**Re: Second Submission Review** – Green Valley Ranch East Site Plan No. 17 - Site Plan with Adjustment and Plat  
Application Number: **DA-1662-28**  
Case Number(s): 2022-4034-00; 2022-3032-00

On behalf of Oakwood Homes, Aztec Consultants, Dewberry Engineering and Terracina Design, we have reviewed the comments dated June 14, 2022. The following is a response to comments.

# GREEN VALLEY RANCH EAST FILING NO. 17 SITE PLAN

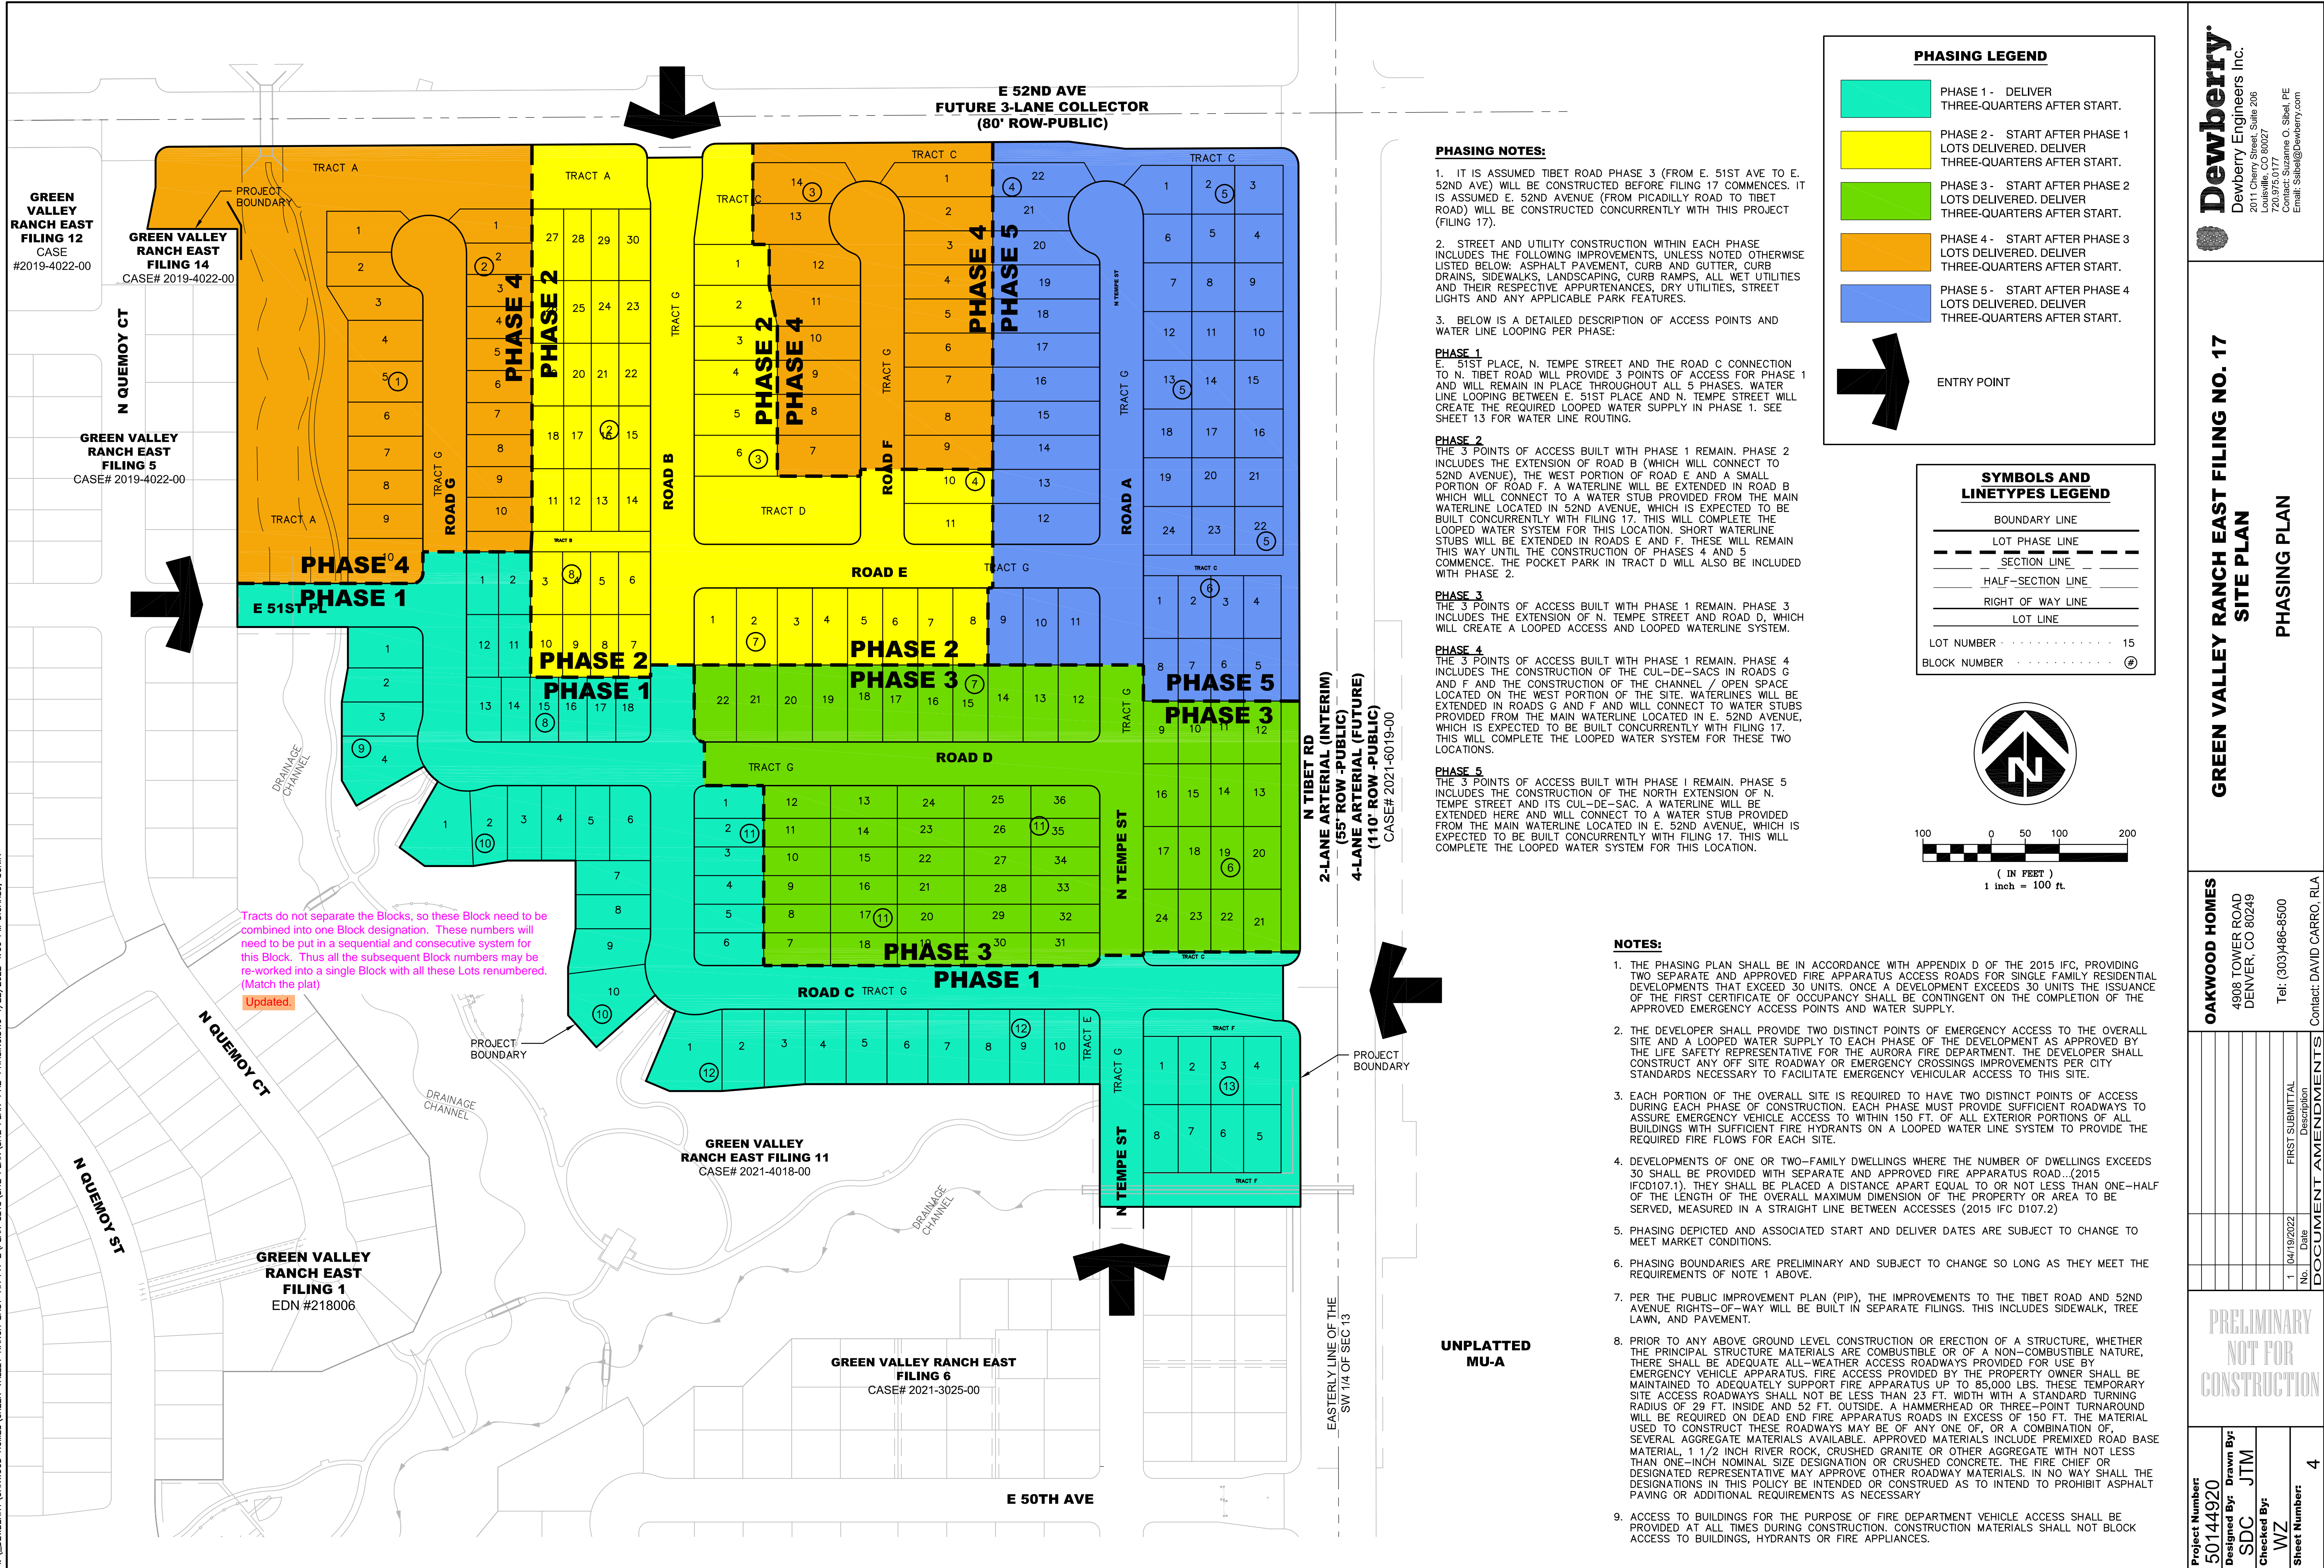
this can't be verified until dimensions are added on individual lots

Acknowledged.

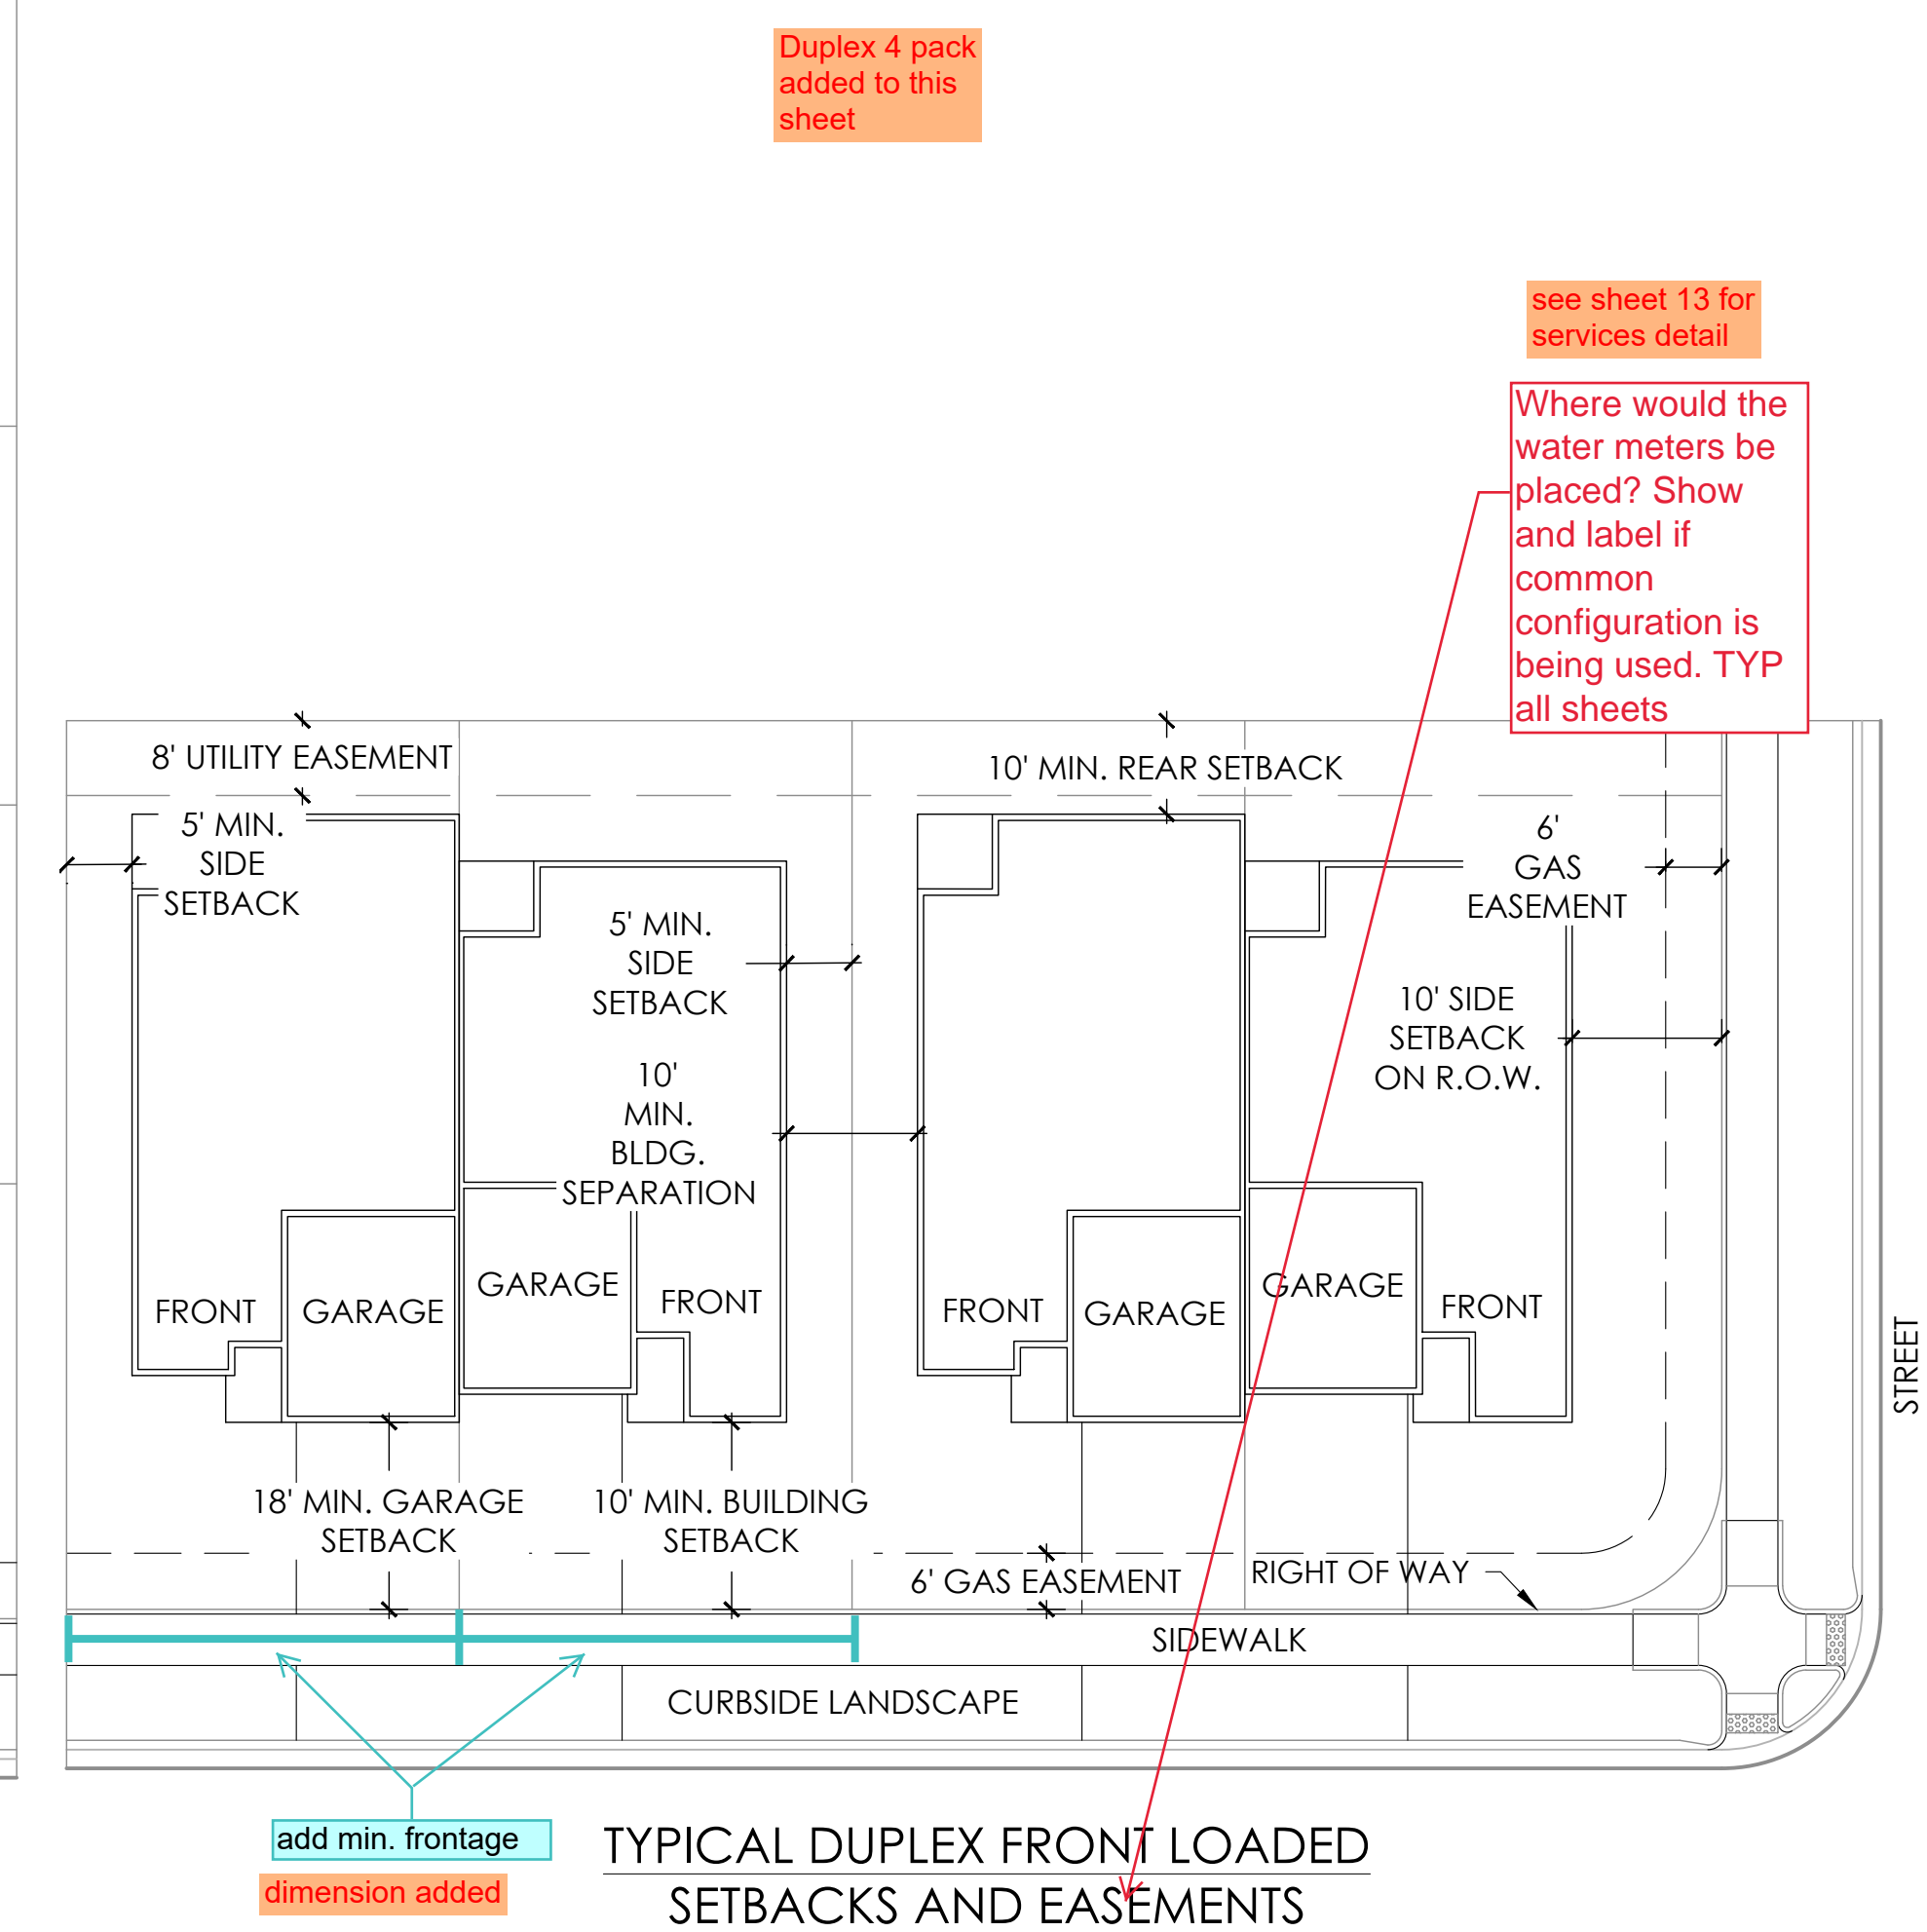
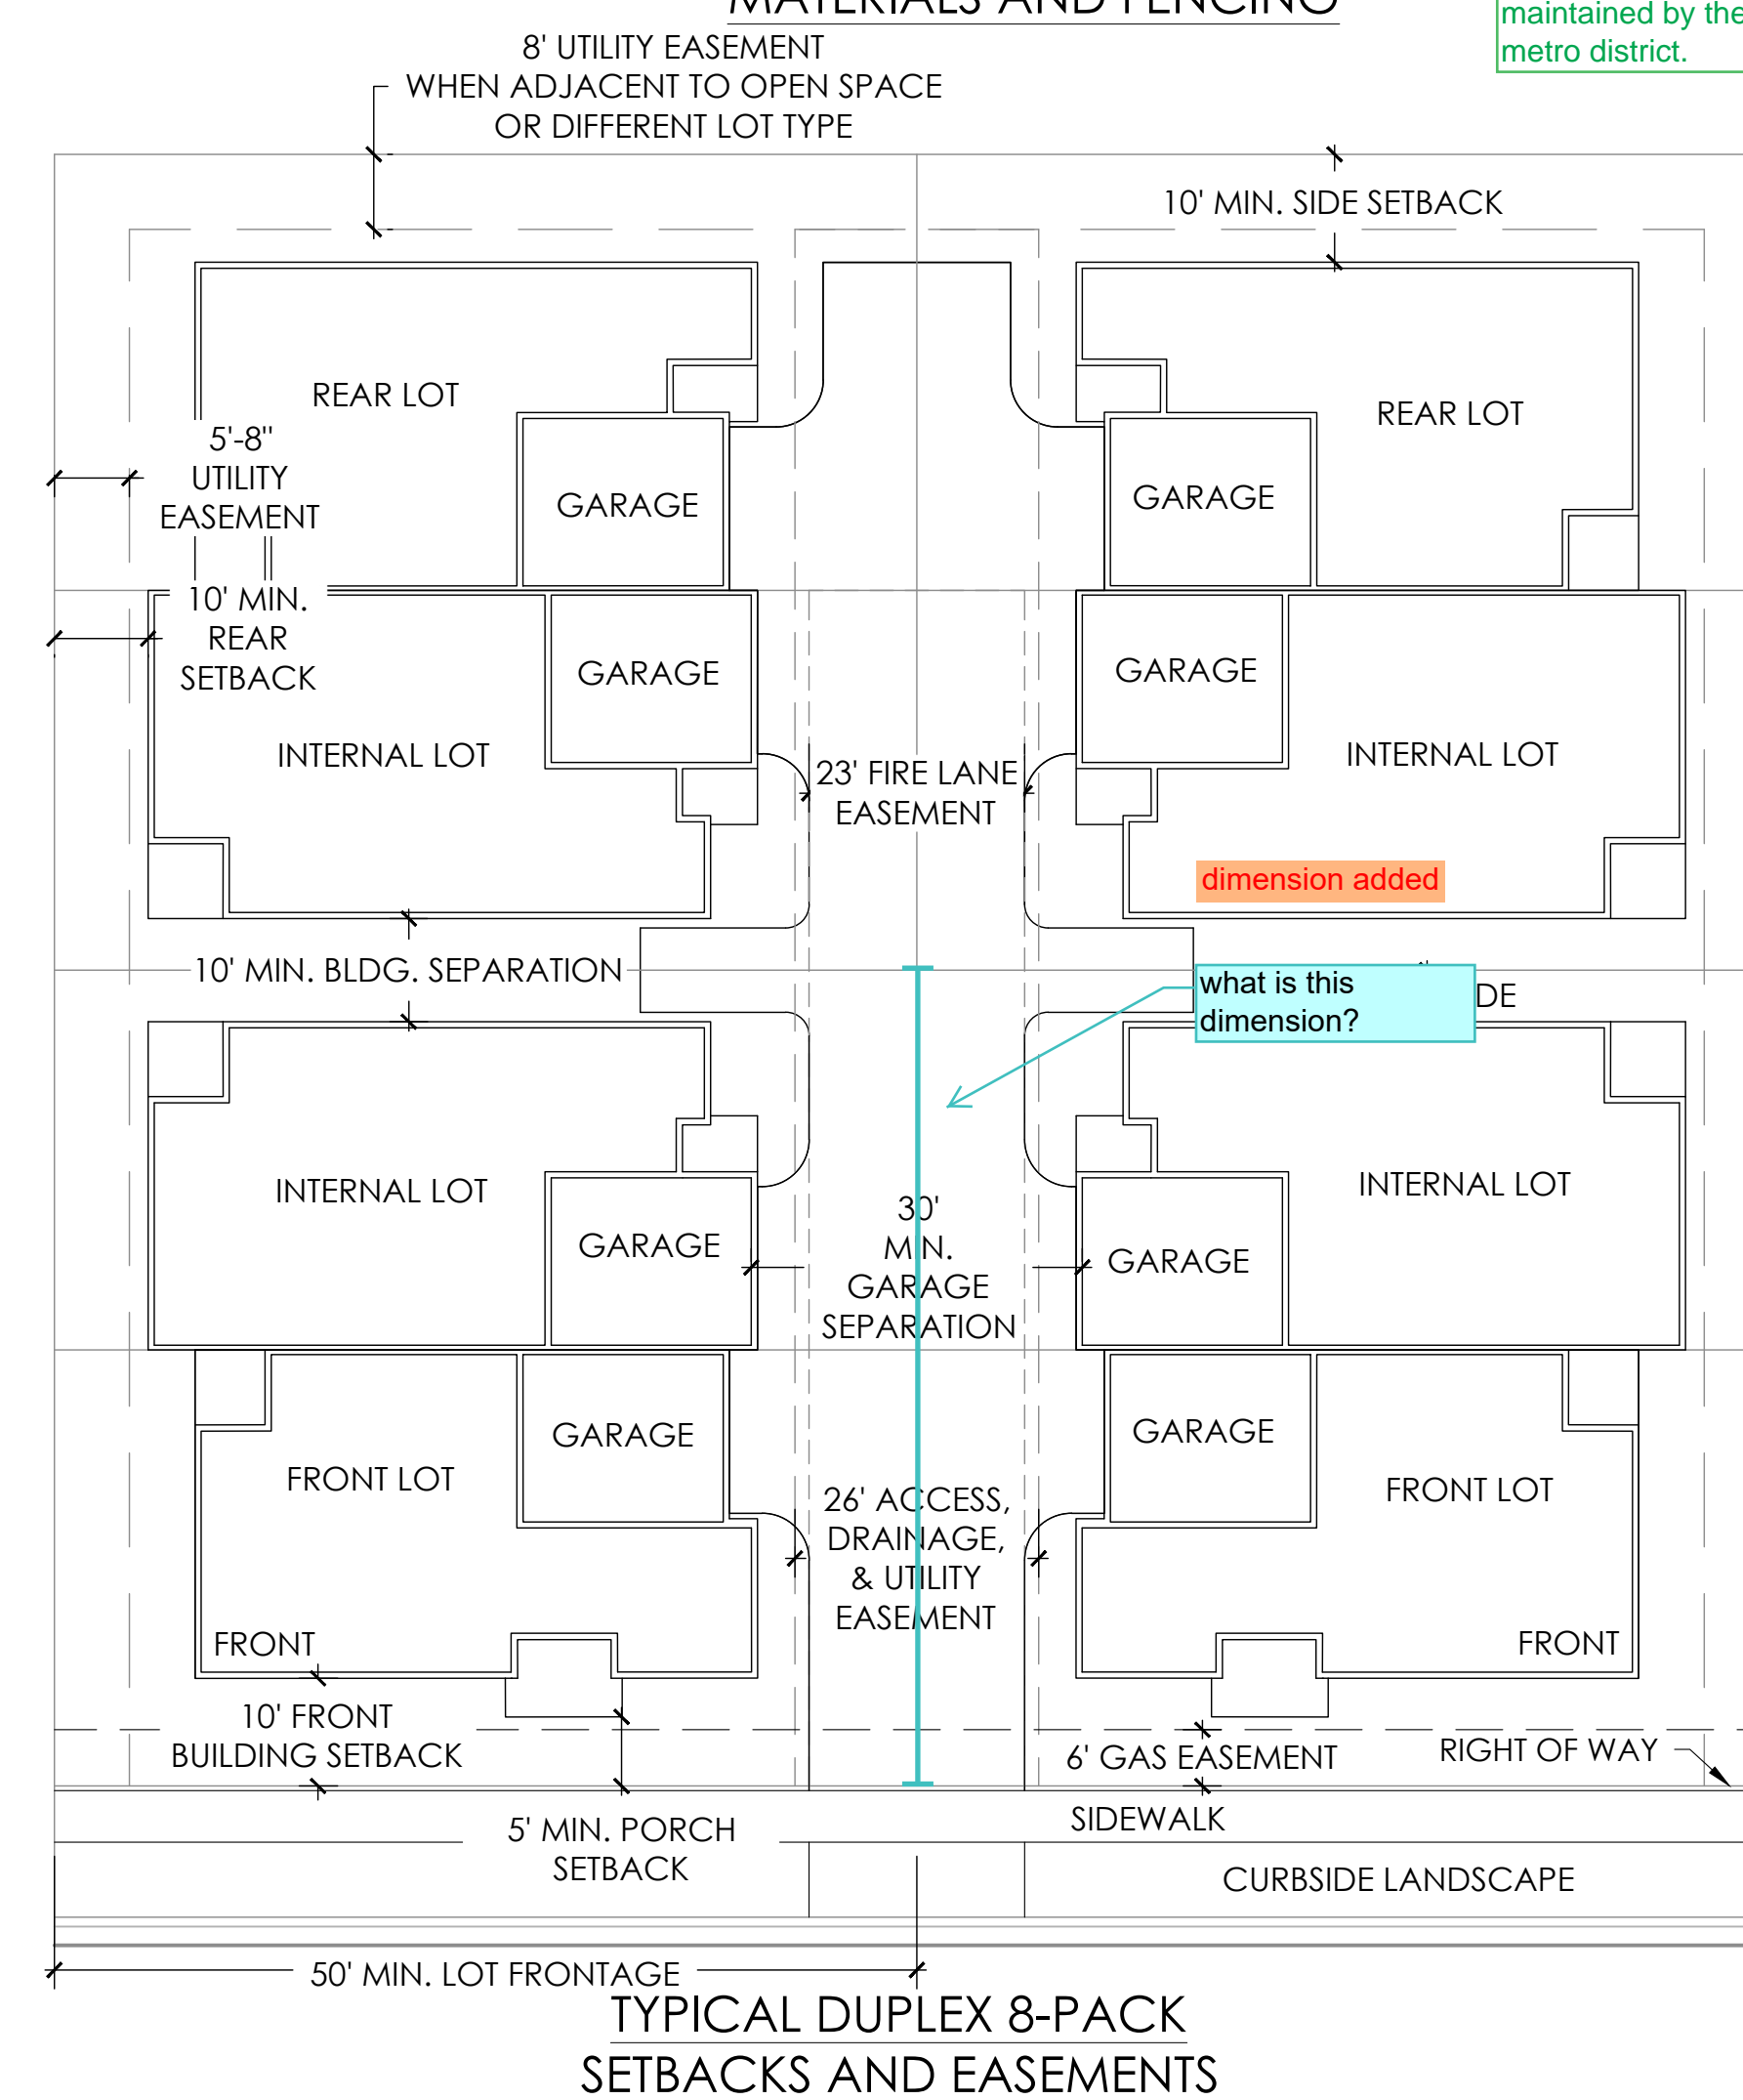
- If applicable, include a detail for duplexes on a through motor court (alley)
- Additional dimensional comments may be forthcoming if the applicant pursues duplexes on a motorcourt

That type of duplex was taken off the plan
